CITY OF CONWAY, ARKANSAS HISTORIC DISTRICT COMMISSION

HISTORIC DISTRICT COMMISSION

1831 Mill Street - New Single-Family Construction

1406 Clifton Street - New Single-Family Construction

1 PROPOSED SITE PLAN
1/8" = 1'-0"

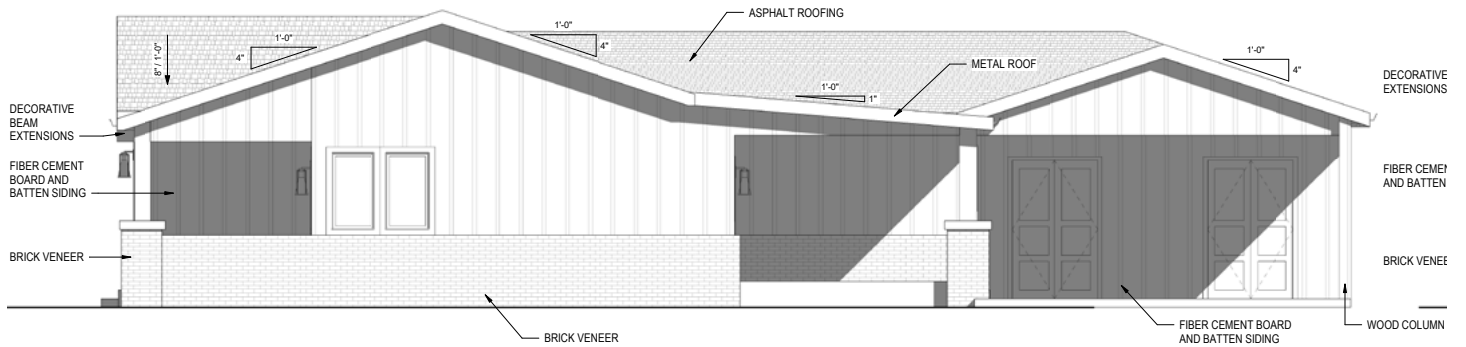
The applicant has indicated a driveway off Mill St near the western property line. Concrete driveway strips are proposed. It appears to be 10 feet wide and terminates at a concrete pad located next to the carport.

A 6-foot wood fence with curved swoop at street end along the western property line is proposed. No other fencing is indicated on the site plan. The fence will need to be 3-½ feet tall where it extends past the front façade of the residence.

It does not appear that any significant trees will be impacted by construction. One new tree will need to be planted.

4. Prior to issuance of a building permit, the lot will need to be replatted.
5. Fencing to the north of the front façade of the residence will need to swoop down to 3-½ feet. The upper 2 feet of the privacy fence shall have 50% opacity. Fencing material shall be wood or wood like composite material.

6. One tree shall be planted. If beneath the power line it shall be an understory tree and if away from the power line it shall be a canopy tree.
7. Windows shall be at least one-over-one (not fixed windows). If muntin bars are used, they must be true divided lights.

8. Driveway shall be concrete, pavers, or permeable paving.
9. Prior to final building inspection, a 5-foot sidewalk with 6-½ foot green space is required.

2 SIDE ELEVATION 1
1/4" = 1'-0"

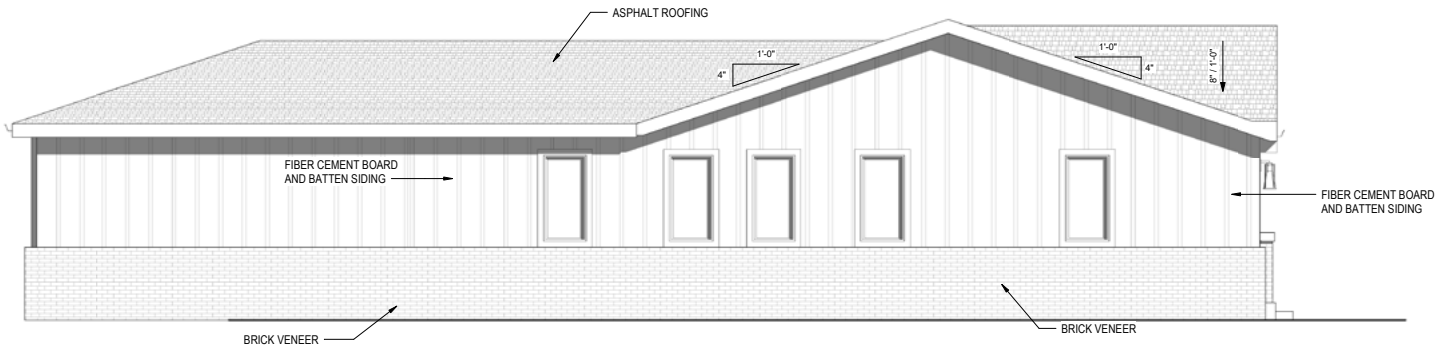
All elevations contain windows including several on the front façade. The west elevation would benefit from an additional 1-2 windows.

2. Additional windows on Side Elevation 1 are encouraged.
3. Additional architectural detailing is encouraged on Side Elevation 2 in the form of windows or changes in the roofline.

3 SIDE ELEVATION 2
1/4" = 1'-0"

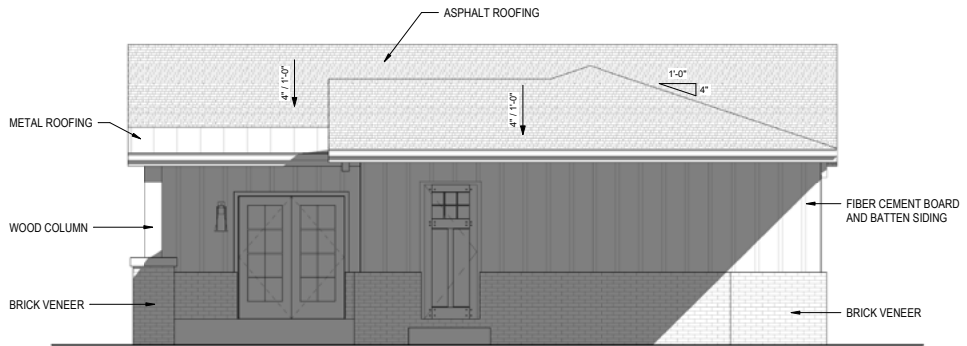
The structures will contain a level of detailing and form that is compatible with the patterns of the area as it is designed according to a gabled ell house with eaves, porches, and materials which complement this design type. The eastern elevation containing the attached carport could benefit from wall or roof breaks. This could be in the form in a change in roof peak and/or windows. However, it appears that this portion of the residence will be minimally visible from the street.

1 PROPOSED SITE PLAN
1" = 10'-0"

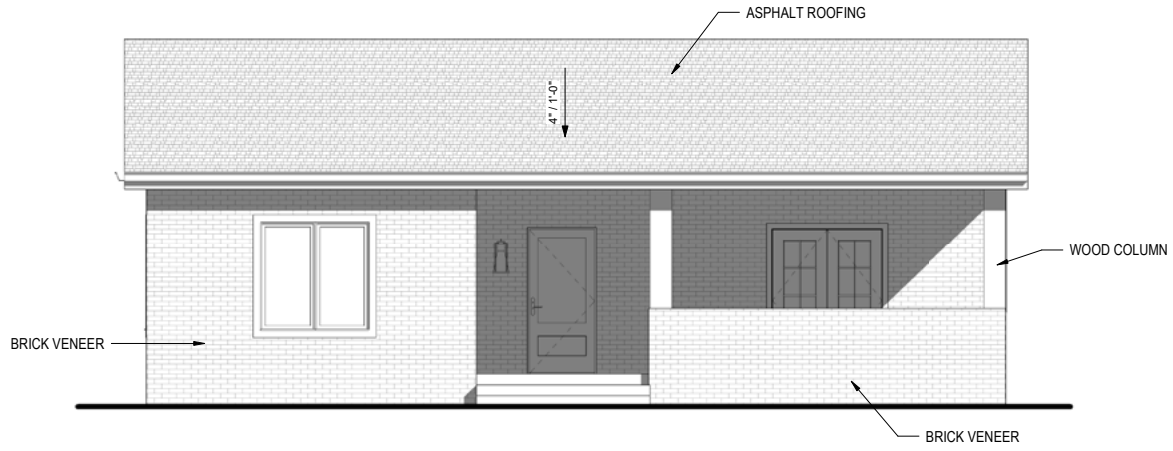
Proposed structure is 6 feet and 12 feet from side yards. The proposed front yard setback is 25 feet from the property line and 15 feet from a utility easement. Staff recommends that the structure be located 18 feet from the property line which is 8 feet from the utility easement. This would also place the residence more aligned with the other residences on the block.

4. Prior to issuance of a Certificate of Appropriateness, the applicant shall provide Planning Staff with an updated site plan showing the structure to be a minimum of 6 feet and a maximum of 18 feet from the dedicated right of way.

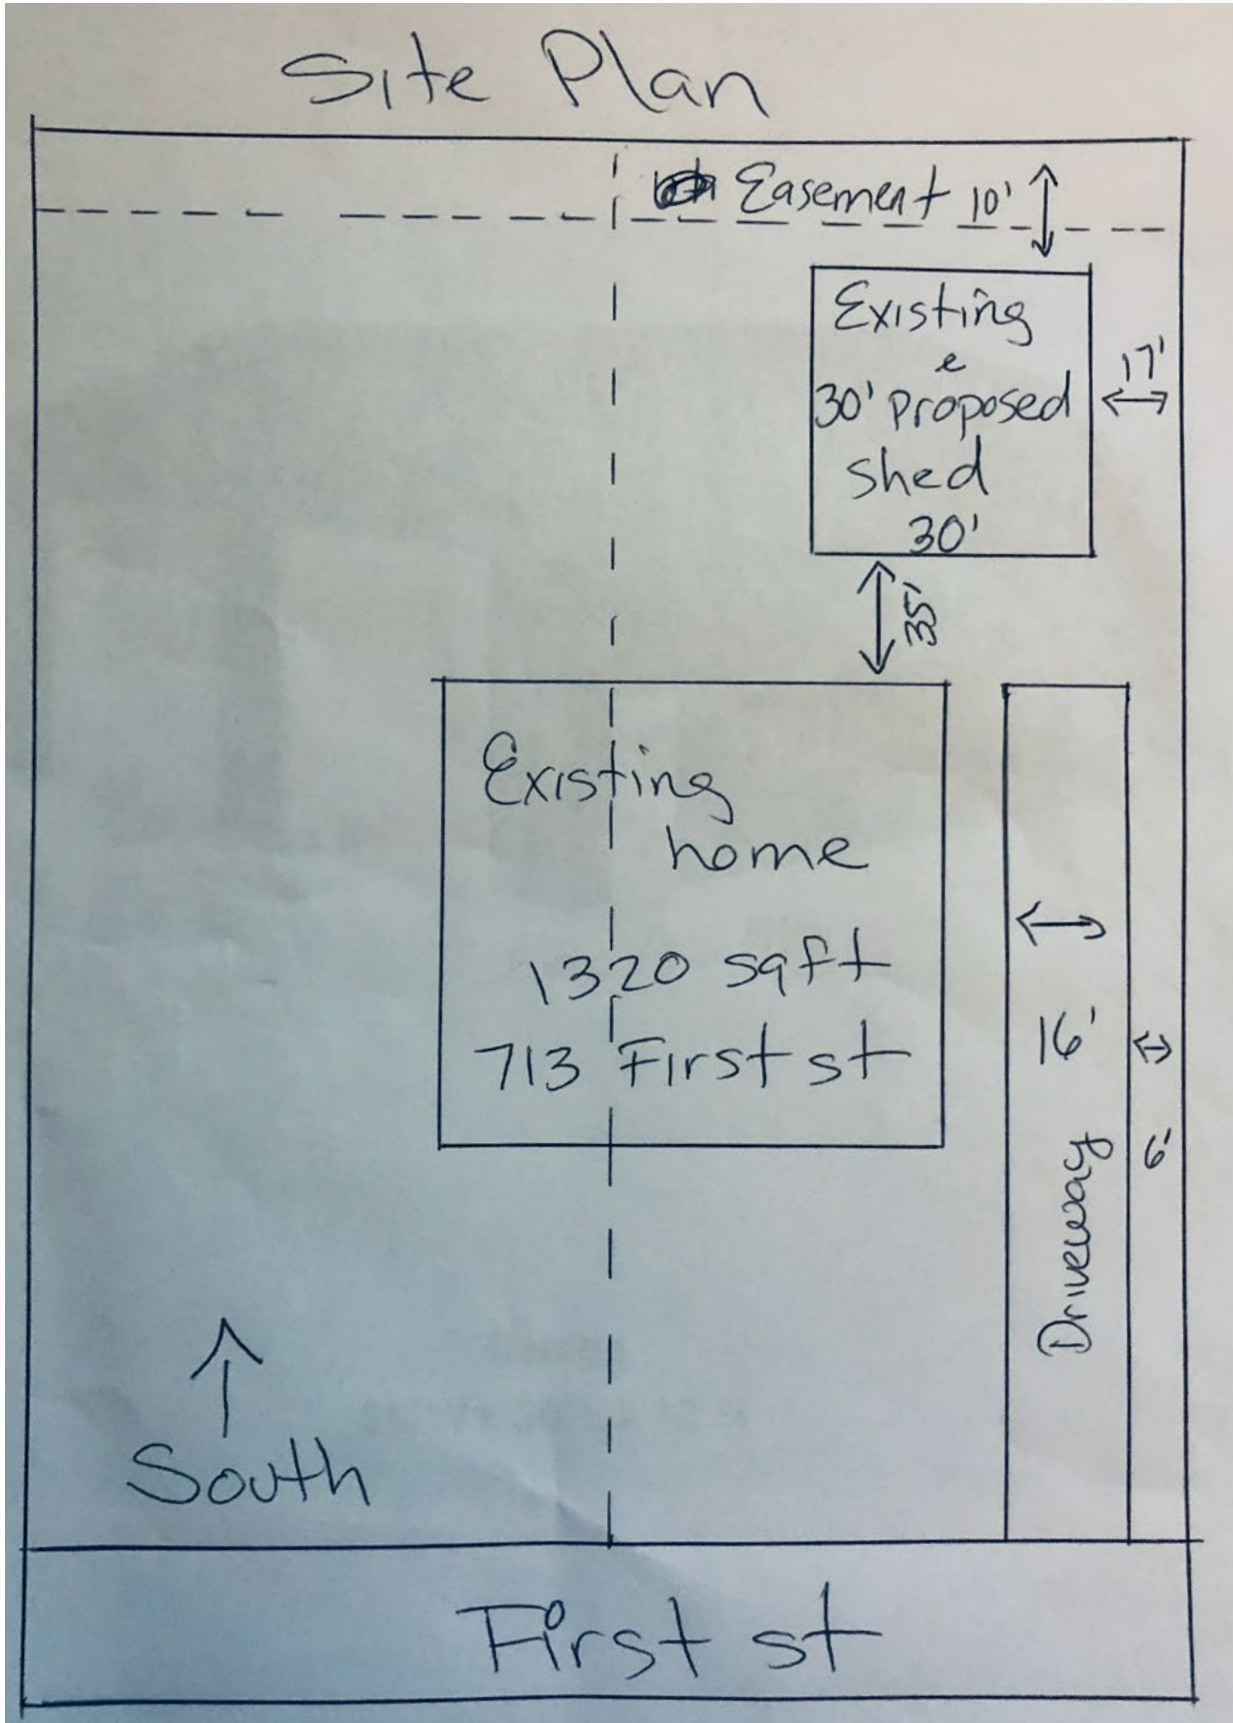
Proposal is for an outbuilding to the rear of the principal structure. The site plan indicates that the outbuilding is 10 feet from the rear property line and 17 feet from the western side yard. Note: The site plan shows an easement. According to the plat, there is no easement, but there is an alley. The alley is not being utilized, but it has never been formally abandoned. The outbuilding will need to be 15 feet from the centerline of this alley.

There is an existing gravel driveway. It appears that to utilize the outbuilding as a garage, the driveway will need to be extended. An extension/reconfiguration of the driveway triggers the need for it to be brought up to current standards which is concrete, concrete ribbon, or permeable pavers.

2. Windows shall be one-over-one. Fake muntin bars are prohibited.
3. Two canopy trees shall be planted along 1st Street.
4. Prior to issuance of a Certificate of Appropriateness, the applicant shall provide Planning Staff with an updated site plan showing the proposed driveway configuration with materials noted. The site plan shall show the parcel boundary dimensions as well as the platted alley to the south to ensure that the outbuilding is constructed 15 feet from the centerline of the alley.

Perspectives provided by applicant

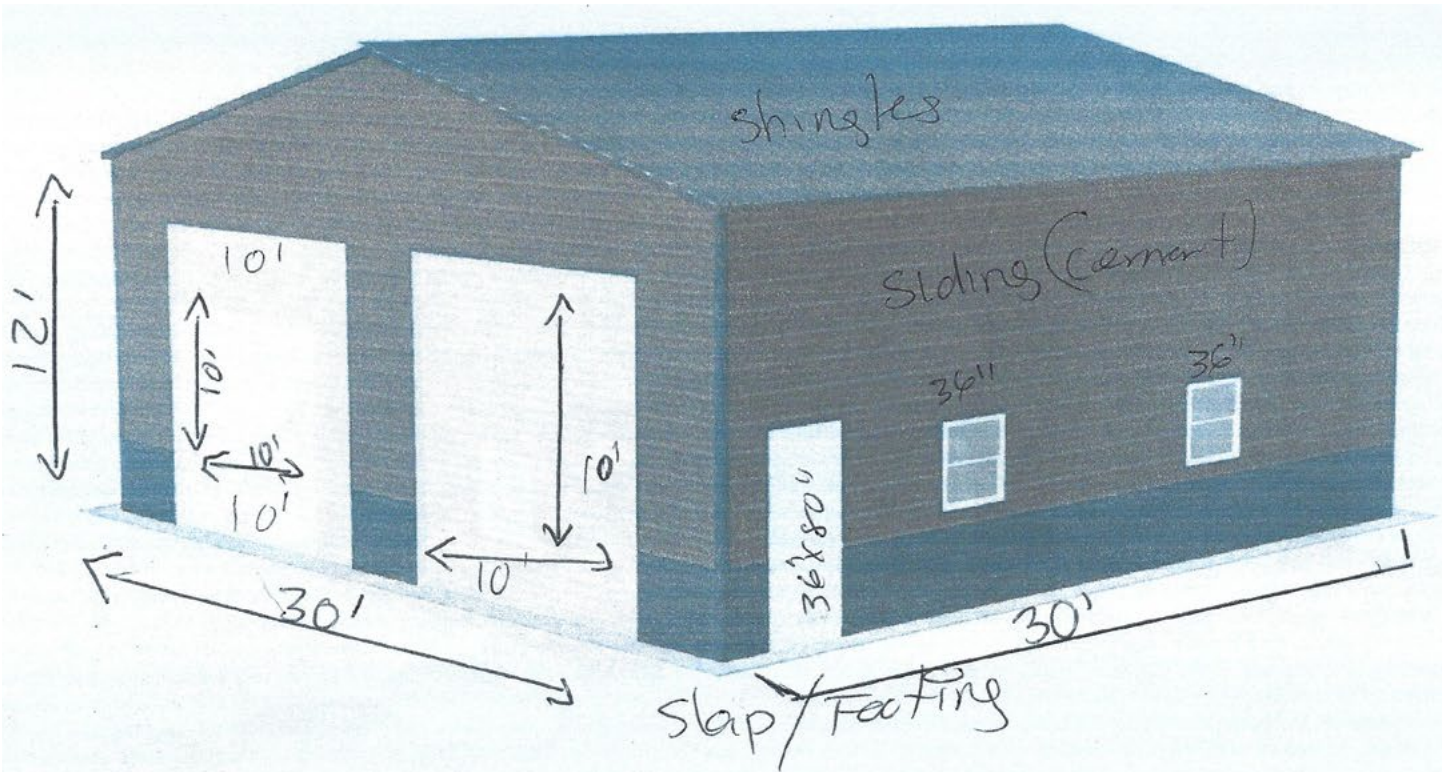
It is unclear what direction the façades face based upon the submitted perspectives. The applicant has informed staff that the double garage door façade will face 1st St. It may be beneficial for the applicant to reorient the double doors to face east or to construct a privacy fence.
